To: T10 Technical Committee
 From: Rob Elliott, HP (elliott@hp.com)
 Date: 11 November 2005
 Subject: 05-306r2 SAS-2 STP connection time limits and STP/SMP I_T nexus loss

Revision 2 (11 November 2005) Incorporated comments from November SAS protocol WG - do not clear the affiliation on an STP I_T nexus loss.

Figure 1 — PL_OC (port layer overall control) state machine

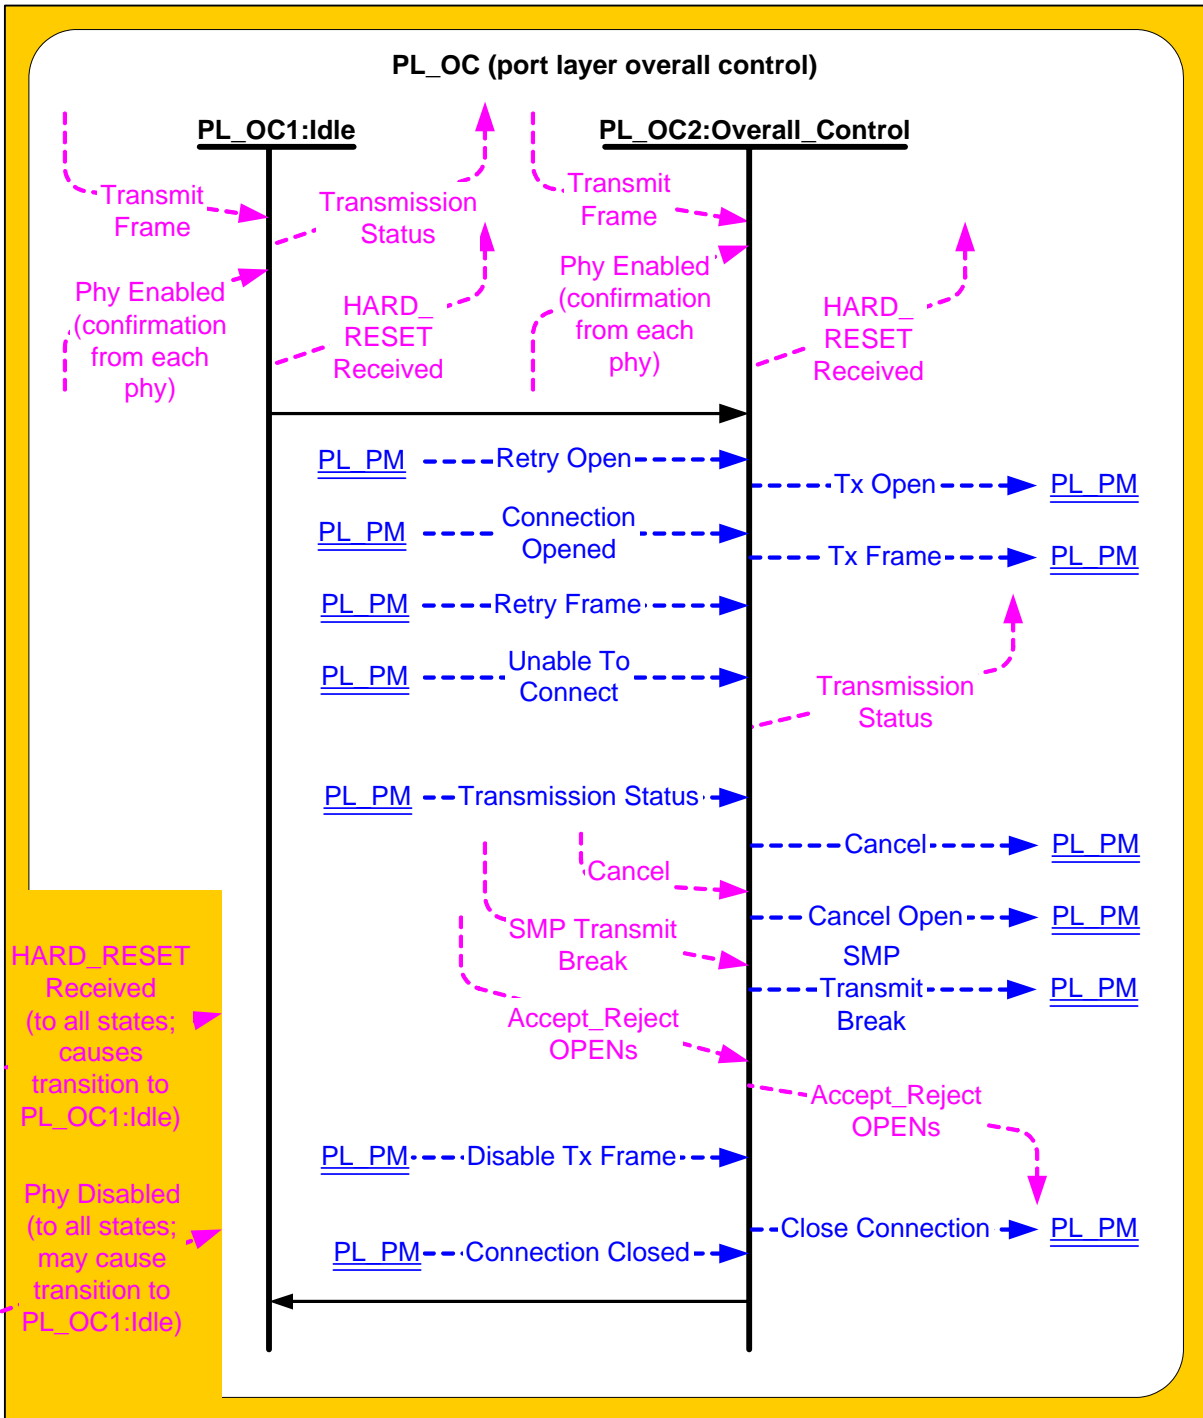
After receiving a Transmit Frame request for a destination SAS address for which there is no connection established and for which no I_T Nexus Loss timer has been created, this state shall create an I_T Nexus Loss timer for that SAS address if:

- ~~a) the protocol is SSP;~~
- ~~b) this state machine is in an SSP target port;~~
- ~~c) the Protocol-Specific Port mode page is implemented by the SSP target port; and~~
- ~~d) the I_T nexus loss time is not 0000h.~~
- [a\) the protocol is SSP, the port is an SSP target port, the Protocol-Specific Port mode page is implemented, and the I_T NEXUS LOSS TIME field in the Disconnect-Reconnect mode page \(see 10.2.7.1\) is not set to 0000h;](#)
- [b\) the protocol is STP, the port is an STP target port, and the STP SMP I_T NEXUS LOSS TIME field in the SMP CONFIGURE GENERAL function is not set to 0000h; or](#)
- [c\) the protocol is SMP, the port is an SMP initiator port, and the STP SMP I_T NEXUS LOSS TIME field in the SMP CONFIGURE GENERAL function is not set to 0000h.](#)

- a) [the protocol is SSP and the port is this state machine is in an SSP initiator port; or then this state may create an I_T Nexus Loss timer for the SAS address. If a state machine in an SSP initiator port and creates an I_T Nexus Loss timer, then the state machine should use the value in the I_T NEXUS LOSS](#)
